**ACURA** ServiceNews

BSN 21396 (0001)

## S/M Fix: ABS & TCS Relays Reversed

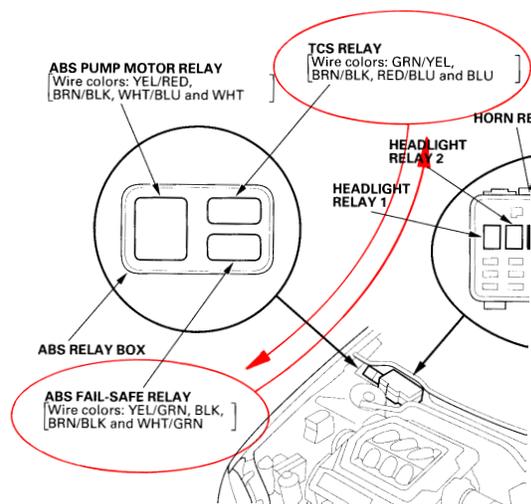
On page 22-7 of the '99-00 3.2TL S/M, the callouts for the TCS relay and the ABS Fail-Safe relay are reversed. Correct the page like this:

## S/M Fix: 3.5RL Glove Box Removal

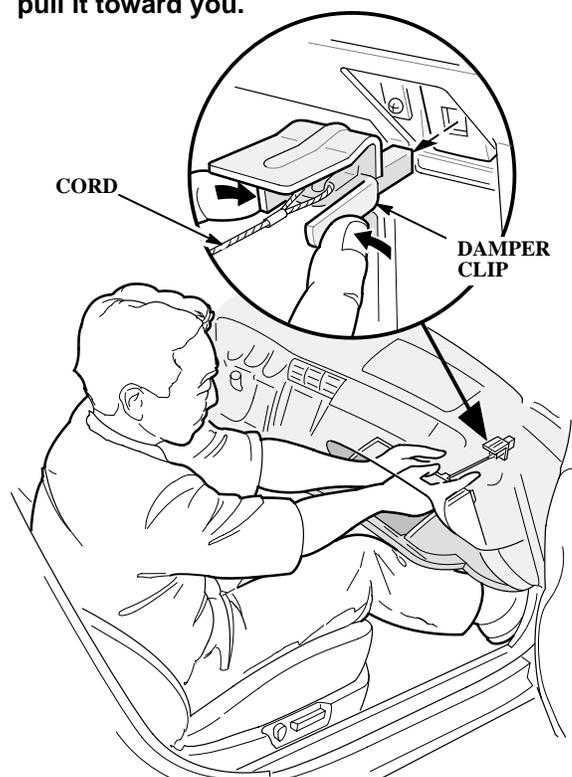
In the '96-00 3.5RL S/M, the glove box removal procedure needs a better description of how to detach the damper clip. On page 20-50, cross out step 3, and write in a note to refer to the January '00 issue of S/N for the damper clip removal procedure. Here's the new step 3 along with a new illustration:

3. Support the glove box with your knee to reduce tension on the damper cord, then squeeze the two tabs on the damper clip and pull it toward you.
